SSD 96505456
DA479/25
JD6 (P&E)

**STATE SIGNIFICANT DEVELOPMENT APPLICATION 96505456
19-23 ROSALIND STREET CAMMERAY
SENIORS HOUSING
PERIFA ROSALIND DEVELOPMENT PTY LTD**

I refer to the recent public exhibition of the above application and thank the Department for the opportunity to provide feedback regarding the proposed development of the subject land. Following a review of the documents submitted, Council objects to the development proposal.

Figure 35 Proposed building form's relationship with adjoining residential development (viewed from Rosalind Street)

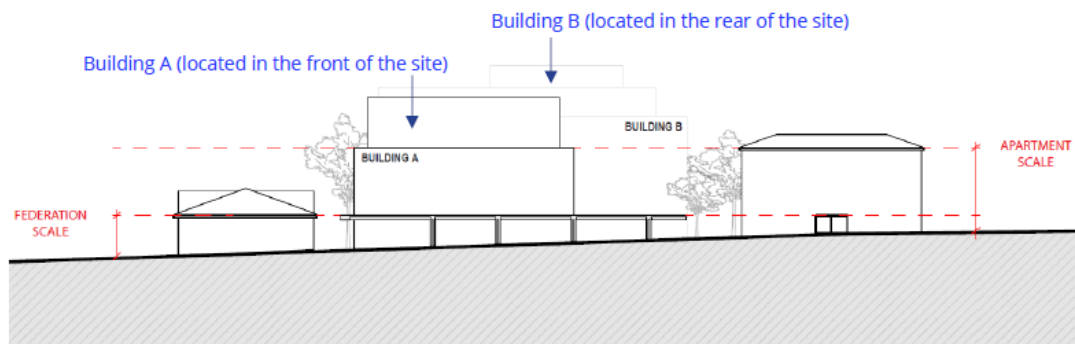
The proposed three-storey street wall element aligns with the immediate context to the west, where a three-storey apartment building is located. However, the interface on the eastern side of the site is of concern, as it adjoins a single-storey duplex.

The existing separation between these buildings exceeds 12m, and the access lane to 23 Rosalind Street provides a buffer that helps soften the transition. In contrast, the proposed design includes a 3m setback to the eastern boundary with a five-storey building, resulting in a more imposing interface.

5. *The impact of the proposal on the locality and streetscape is unacceptable. The design should be reviewed to have an acceptable impact, addressing issues raised in this submission.*

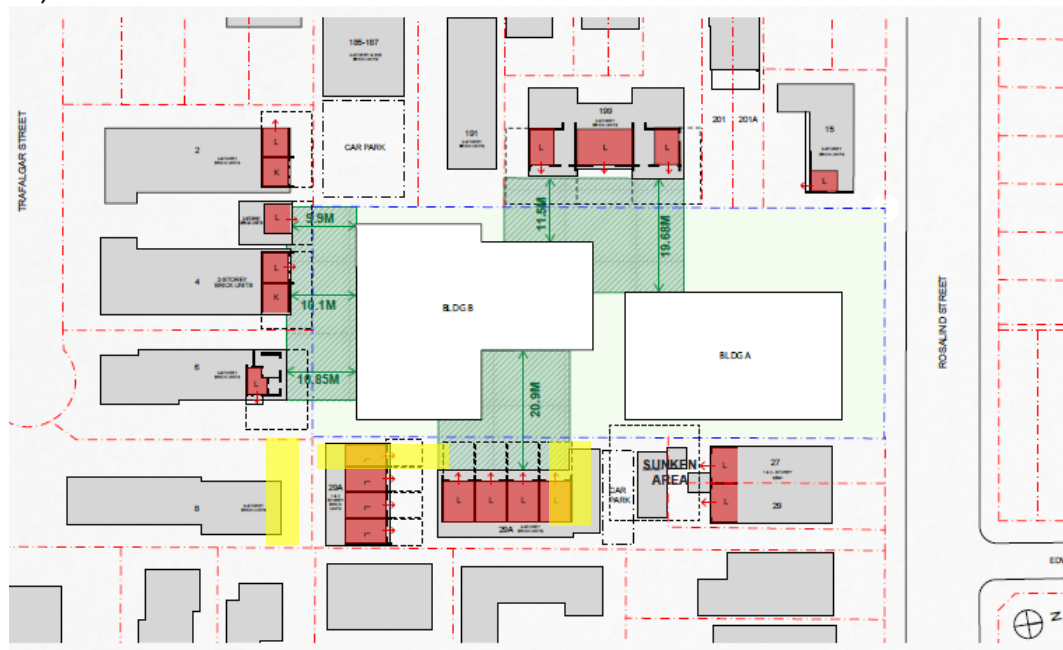
Elevation shadow diagrams allow comparison of overshadowing of buildings at, for example, 4 Trafalgar Street, south of the site. The diagrams show little difference between a 'compliant scheme' (which is non-complaint) and the proposed design. However, the shadow diagrams in plan-view (DA 400) indicate the extent of overshadowing by the proposal is significantly greater than existing shadows, and there is no diagram depicting shadows cast by a properly devised 'compliant' building envelope.

The proposed five-storey Building A would significantly reduce afternoon solar access to the private open spaces (highlighted in yellow on the image below) of 27, 29, and 29A Rosalind Street.

27 Rosalind Street

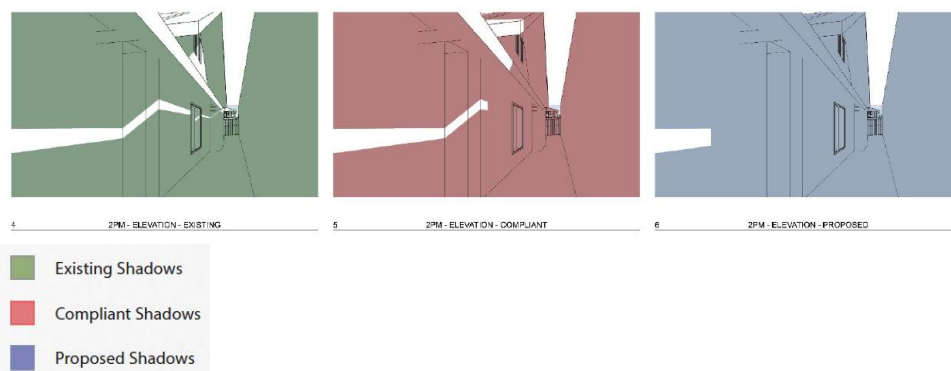
The submitted solar access diagrams primarily assess shadow impacts on the western façade of 27 Rosalind Street. However, the most significant impact is on the private open space, which has not been assessed.

In addition, the shadow impacts shown for the 'compliant scheme' in the provided diagrams are misleading, as the 'compliant scheme' (referring to the image below) does not reflect an approach that considers the design and context of the

29A Rosalind Street

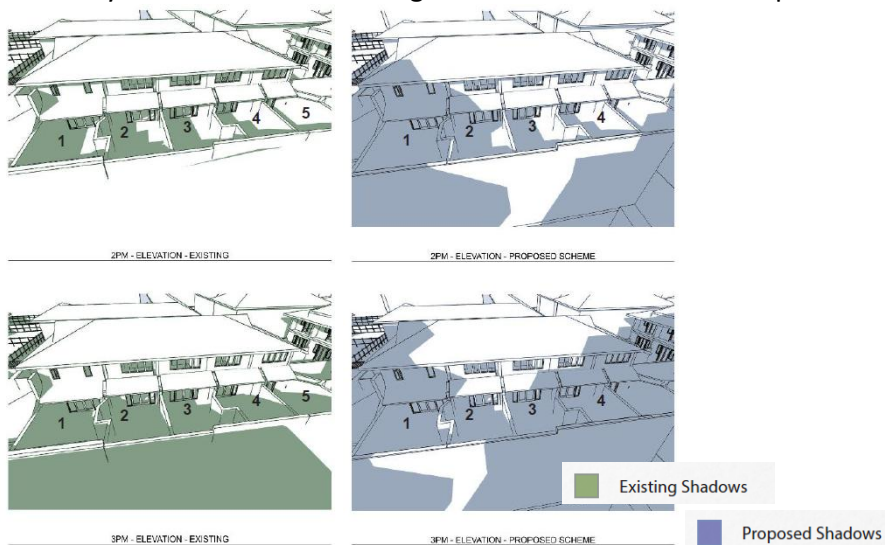
The proposed Building A would result in additional shadowing to 29A Rosalind Street after 1.00 pm during mid-winter. Providing a compliant setback to the eastern boundary would assist in reducing these additional shadow impacts.

Privacy

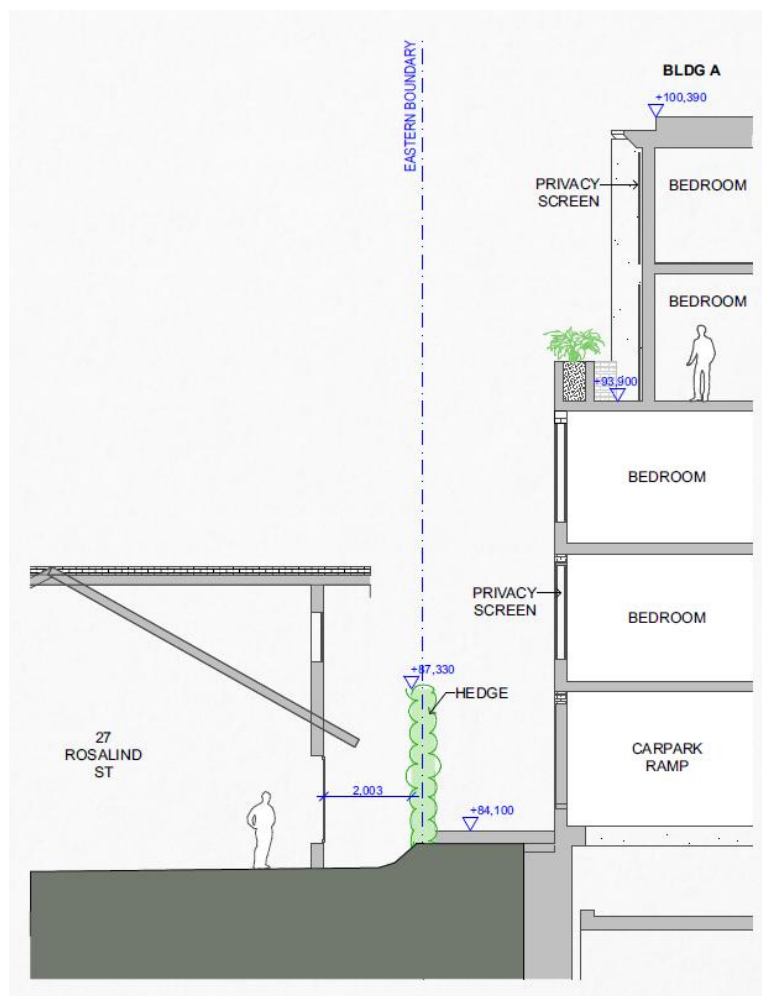
Regarding privacy, Building B and its balconies partly have adequate separation (boundary setbacks) at lower levels, at upper levels balconies protrude into the 9.0m/12.0m building separation setbacks, contrary to the ADG's guidance. Level 4 in Building A (5 levels above finished ground level) has only a 5m setback to the boundary with lower levels setback 3.0m. These should be at least 9.0m and 6.0m respectively, the adjoining land being zoned R4, like the site.

The design seeks to reduce privacy impacts resulting from inadequate building separation, by screening habitable room windows and via orientation. On a large site capable of accommodating setback-compliant built form, proposed solutions are unacceptable. On the eastern boundary, hedges are partly relied upon to maintain privacy and should not be.

Zoning of site (yellow outline) and surrounds (eplanning spatial viewer)

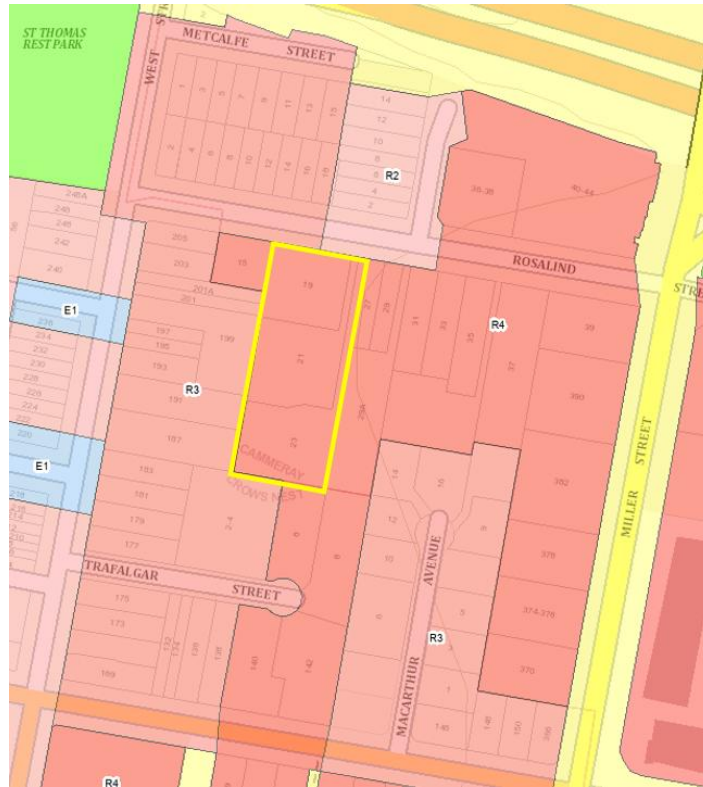
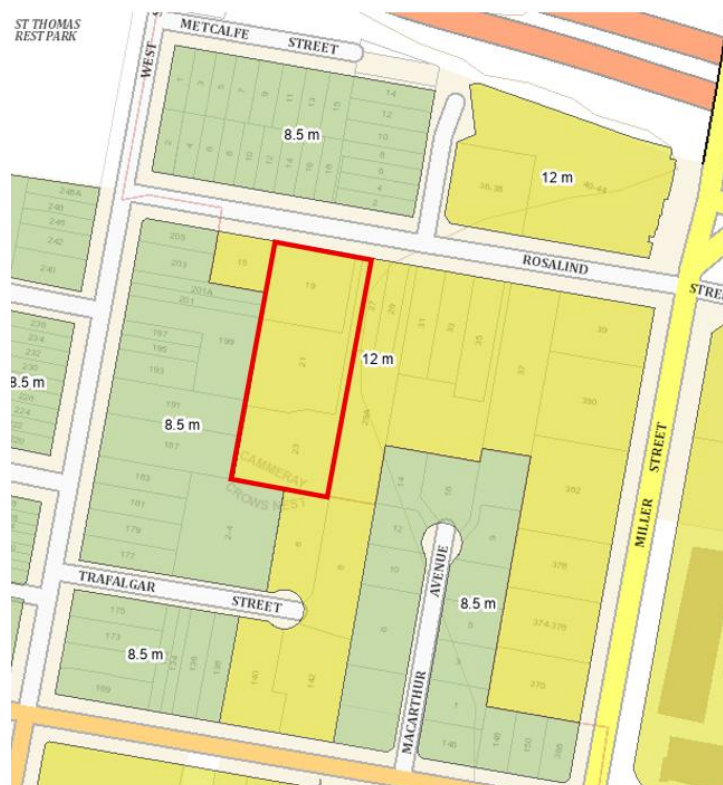
As the applicant's request notes, adjoining land is zoned R2 to the north, R3 to the west and R4 to the east and south. These zones are shown below, and another LEP map extract that follows shows corresponding height controls. When development of adjoining land is consistent with zoning and height controls, and complemented

by appropriate setbacks depending on development type, harmonious transitions can be created. With the height of the two buildings exceeding the bonus height and with inadequate setbacks to side boundaries proposed, except Building A's setback to the western boundary, the urban design and amenity impacts are by comparison with a compliant development, significant and unacceptable.
